RPRC RETURN LETTER

Street Location: 14 CAREY DR

RE: Persky Residence – 14 Carey Drive – TaxID: 102.02-1-7

Residential Project Review Committee Response Letter:

GROSS LAND COVERAGE CALCULATIONS WORKSHEET

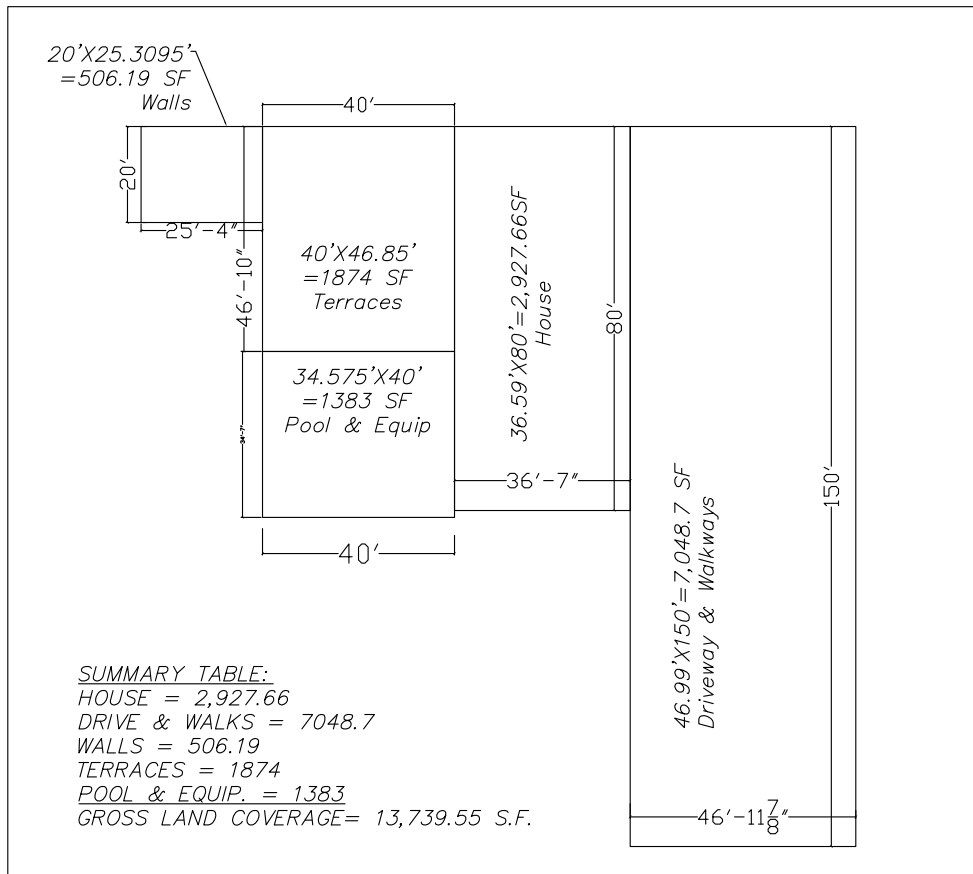
4. The Applicant should submit a gross land coverage backup exhibit for review.

Response: A gross land coverage backup exhibit was provided on sheet RPRC-1. We have updated it per the new site design, as well as provided a separate document.

SITE PLAN
 RPRC PERMIT PLAN

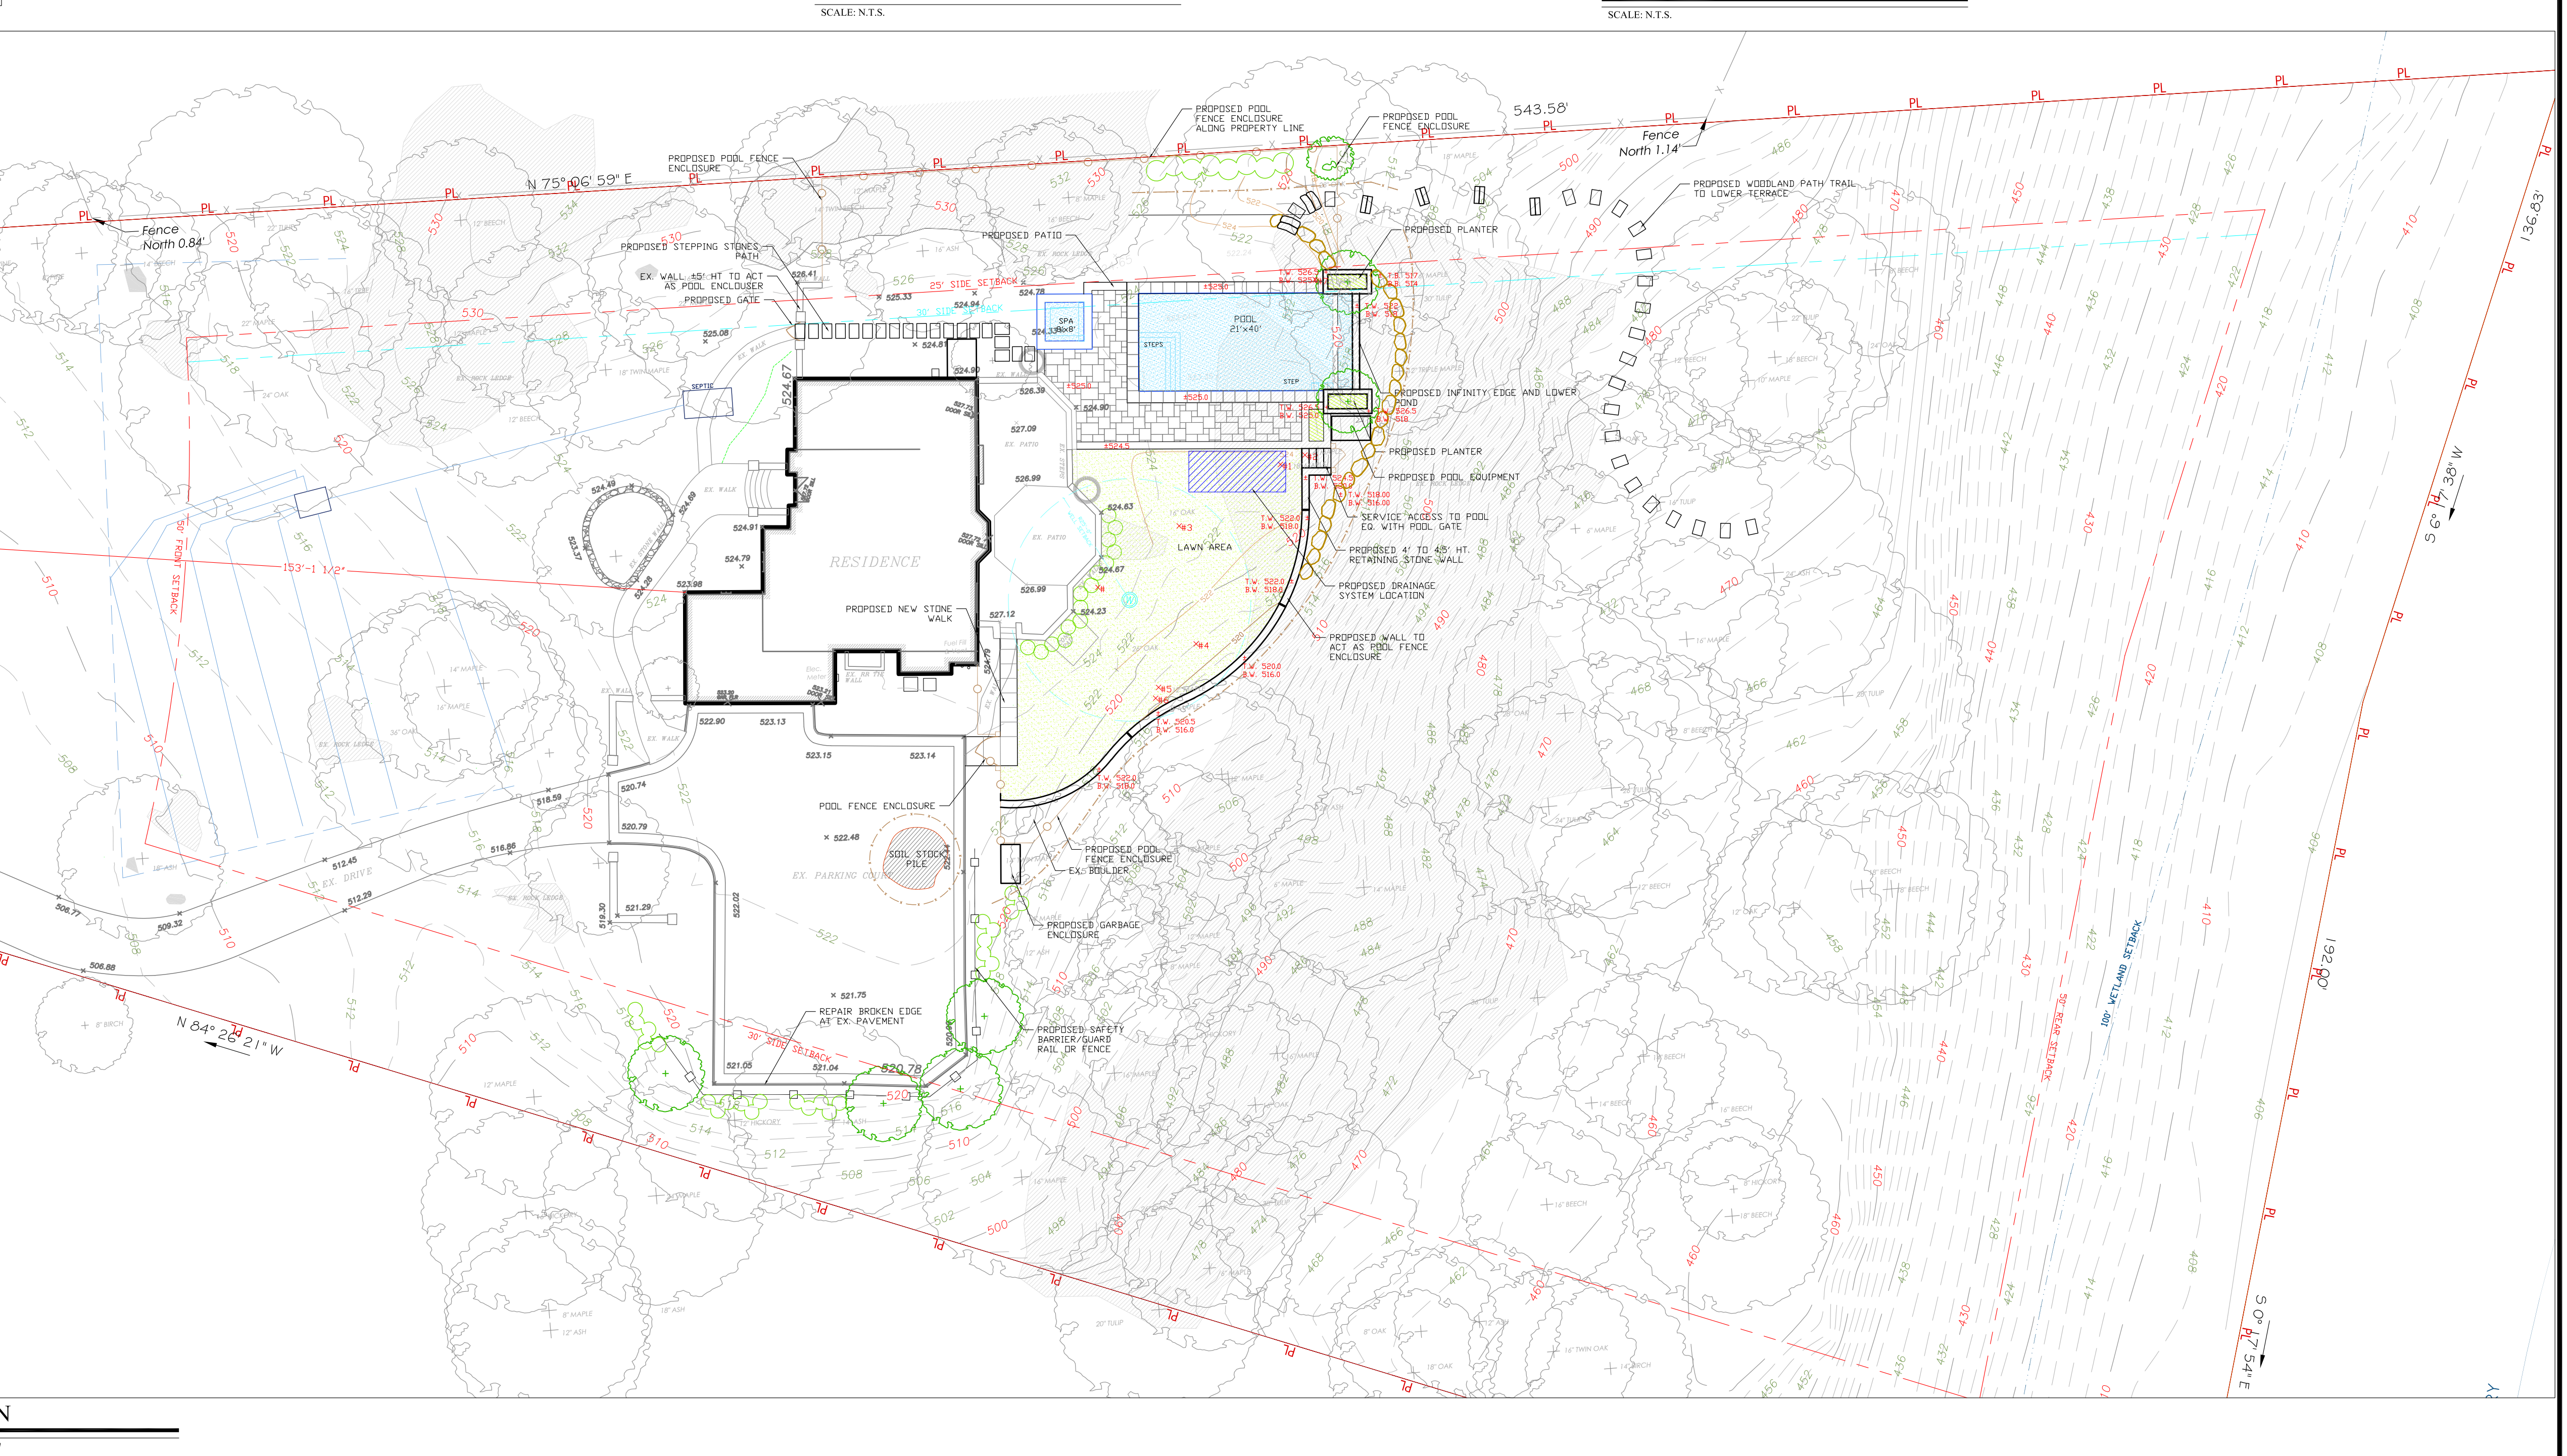
1. Portions of the proposed pool patio and spa do not meet the minimum required side yard setback. It is not clear why the pool complex can't be constructed at the rear, in the proposed lawn area and meet the minimum requirements of the Town Code. In addition, this lot may be a part of a Conservation Subdivision. If so, the required side yard setback may be 25 feet, not 30 feet. The Applicant should provide additional information regarding the minimum required setbacks for this lot.

2. The site plan should be revised to depict any proposed Town-regulated tree removal. The site plan should note if any tree removal is proposed in the "lower terrace" level. If tree removal is proposed, the Applicant should return to the RPRC for further evaluation.

Response: The site plan has been adjusted to keep the proposed pool within the required side yard setback, per the conservation subdivision setback of 25 feet.

Response: We have noted on the site plan all proposed tree removals showing their location, size and tree type.

BOULDER WALL DETAIL
SCALE: 1/2" = 1'-0"
4 D-1

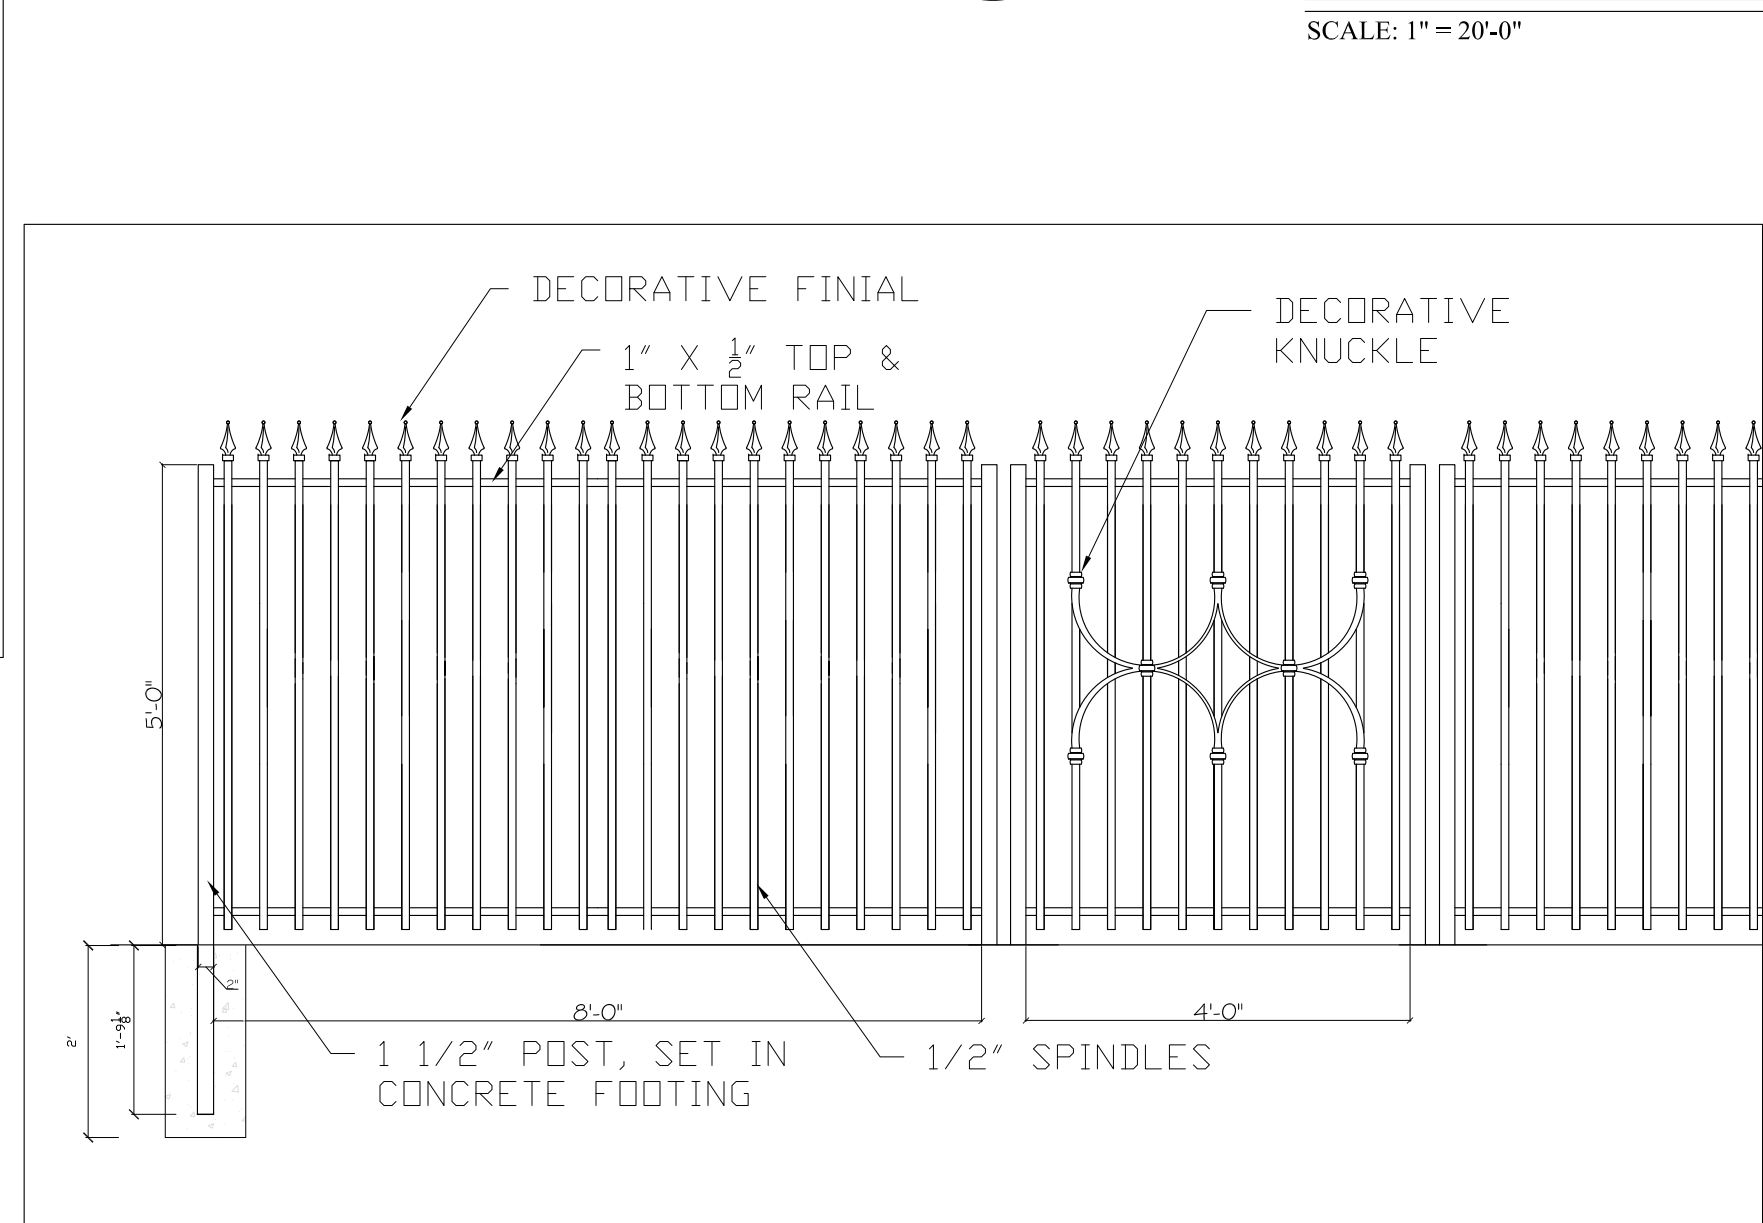
6. The wall, however, only looks to be three (3) feet high within certain locations.

Response: The proposed boulder wall ranges from 2 feet to 3 feet high.

POOL FENCE & ENCLOSURE DETAIL
SCALE: 3/4" = 1'-0"
7 D-1

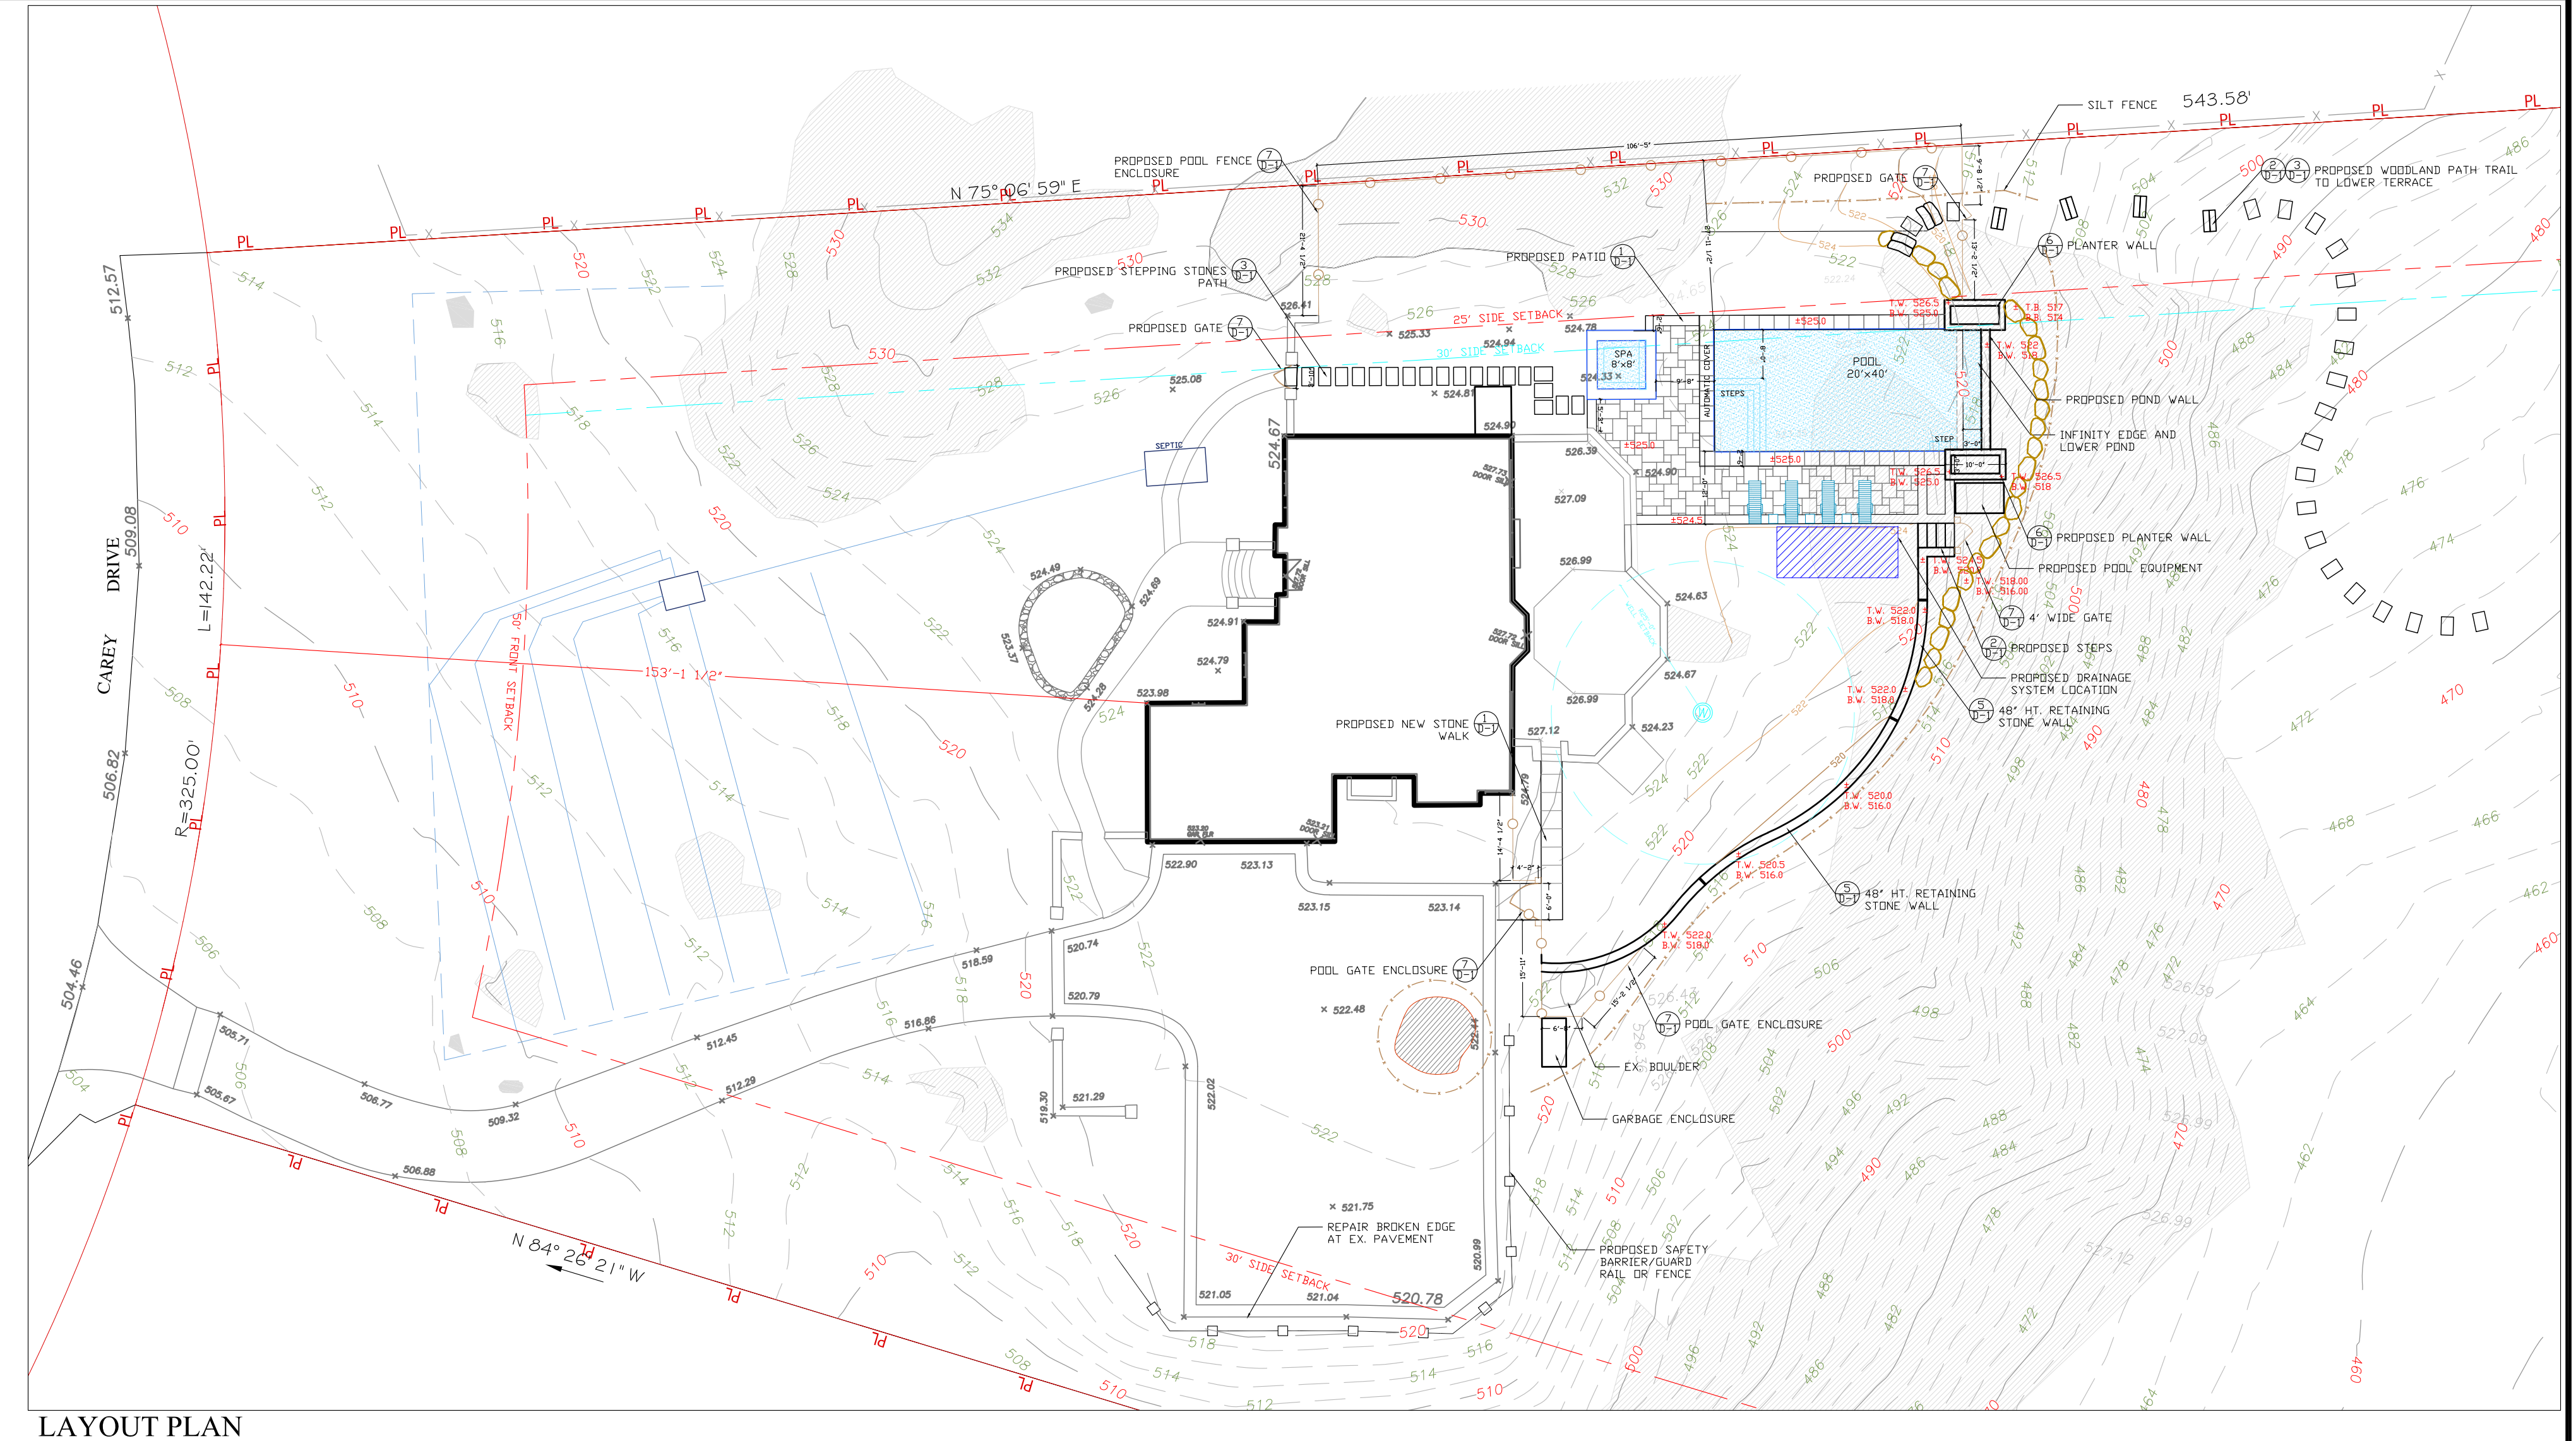
8. Provide fence and gate details, including height, material, post installation, etc. The plan shall delineate the limits of each fence type and locate all gates.

Response: The proposed pool fence has been shown on the plan and details have been provided on sheet D-1.
